Reviewer comments

Stefano Macrì, Sandrine Aubrun, Annie Leroy, Nicolas Girard

1 Response to reviewer 1

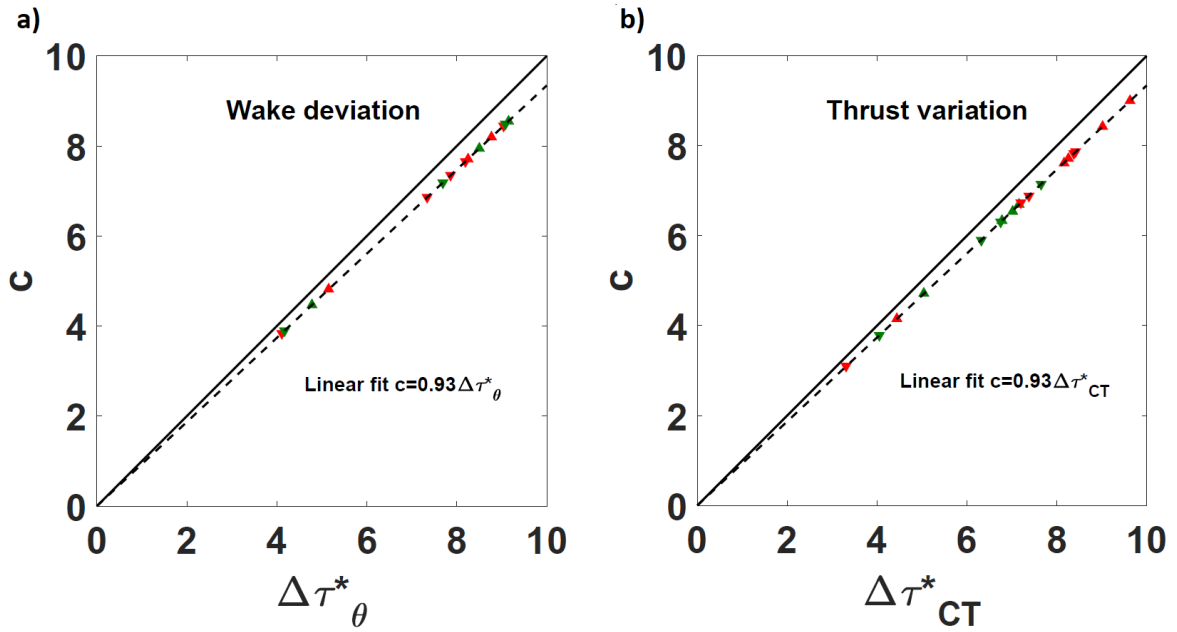
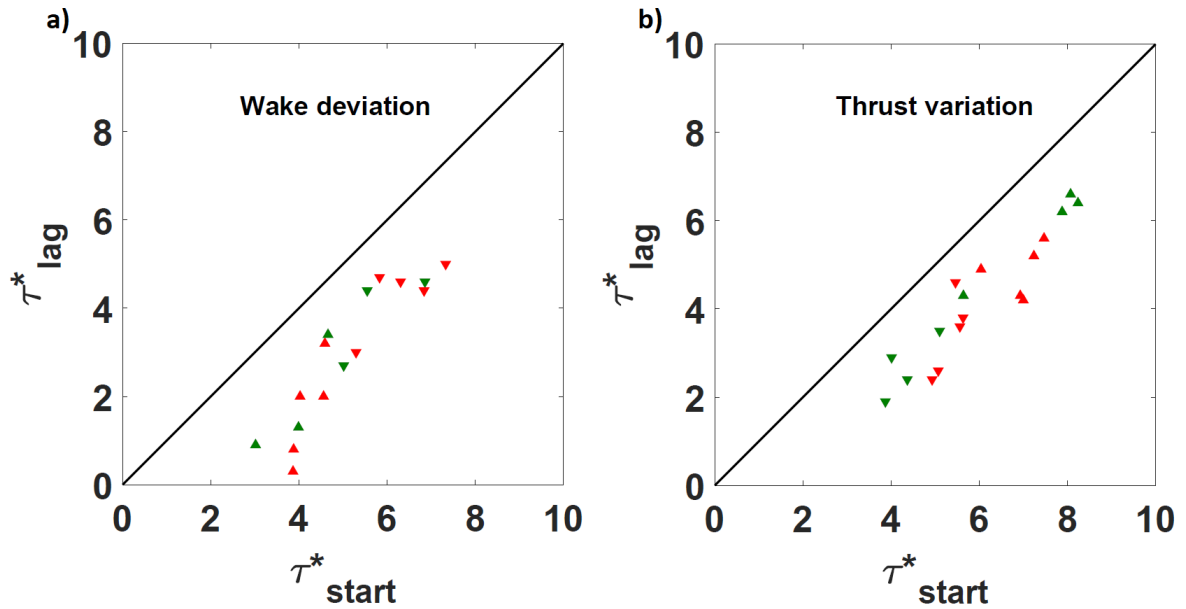
- If the fit functions in Eqs. (7) and (8) are applied to the estimated yaw center and change in thrust of the downstream turbine, shouldn't τ_{lag} represent the convective time between the upstream turbine and either the measurement location or the downstream turbine? Also, the transient dimensionless duration is missing 10% of the fit, and thus will systematically underestimate the actual duration. This will lead to misleading values of $\Delta\tau^*_{ratio}$.

- Authors state that ""Theoretically, the fitting coefficient τ_{lag}^* (Tables 3 and 4) can be interpreted as a time delay before the transient starts. Unfortunately, there is no clear relationship between this parameter and the τ_{start}^* start. This illustrates the difficulty of capturing the actual transient start for the present study." It seems like τ_{start}^* should be τ_{lag}^* plus the time required for the function to reach 0.5 based on the parameter c .

In order to answer these questions, a new section 5.4 has been added to the paper. It explains that τ_{lag} can indeed be interpreted as the convection time and c as the transient duration. A discussion on the consequence of the use of thresholds to determine the start and end is also added.

Regarding the fitting coefficients interpretation, a new section (section 5.4) has been added to the paper, dealing explicitly with this topic. Therefore the statement reported by the reviewer has been modified as it follows:

Theoretically, the fitting coefficient τ_{lag}^* (Tables 3 and 4) can be interpreted as a time delay before the transient starts. The relationship between this parameter and τ_{start}^* will be investigated in section 5.4 together with the relation between c and the transient duration.

In this section, an evaluation of the fitting coefficients of the exponential law is done with respect to the timing parameters used for the transient analysis. In figure 1a, the wake deviation duration $\Delta\tau_{\theta}^*$ is plotted against the c coefficient of the fitting law for both positive and negative manoeuvre and porosities levels, while in figure 1b, the same analysis is done for the thrust variation duration $\Delta\tau_{CT}^*$. Generally c has a very clear correlation with the duration for both wake deviation and thrust variation cases. Indeed, it is possible to retrieve by linear fitting imposing the fit law to pass through the origin, a linear relationship that links c to both wake deviation and thrust variation duration. This linear fitting was done separately for the wake deviation and thrust variation but led to the same slope of 0.93:

$$c = 0.93\Delta\tau^* \quad (1)$$

where $\Delta\tau^*$ is either the wake deviation duration $\Delta\tau_{\theta}^*$ or the thrust variation duration $\Delta\tau_{CT}^*$. These results confirm the robustness of the fit coefficient c although the reason that keeps c constantly lower than the phenomenon duration still needs to be investigated. In figure 2a, the start of the wake deviation τ_{start}^* is plotted against the τ_{lag}^* coefficient of the exponential fitting laws for both positive and negative manoeuvre and porosity levels. In figure 2b, the same analysis is done for the start of the thrust variation. Several considerations on the τ_{lag}^* coefficient can be made. Indeed, although it can be observed a higher scatter than for the c coefficient, τ_{lag}^* also shows a detectable trend. The thrust data seems to have lower scatter than the wake deviation data and this could be related to the higher time resolution of the load measurements. There is generally a bias between the values that oscillate between 1 and 2 τ_0 . This could be partially attributed to the threshold value used for the τ_{start}^* determination.
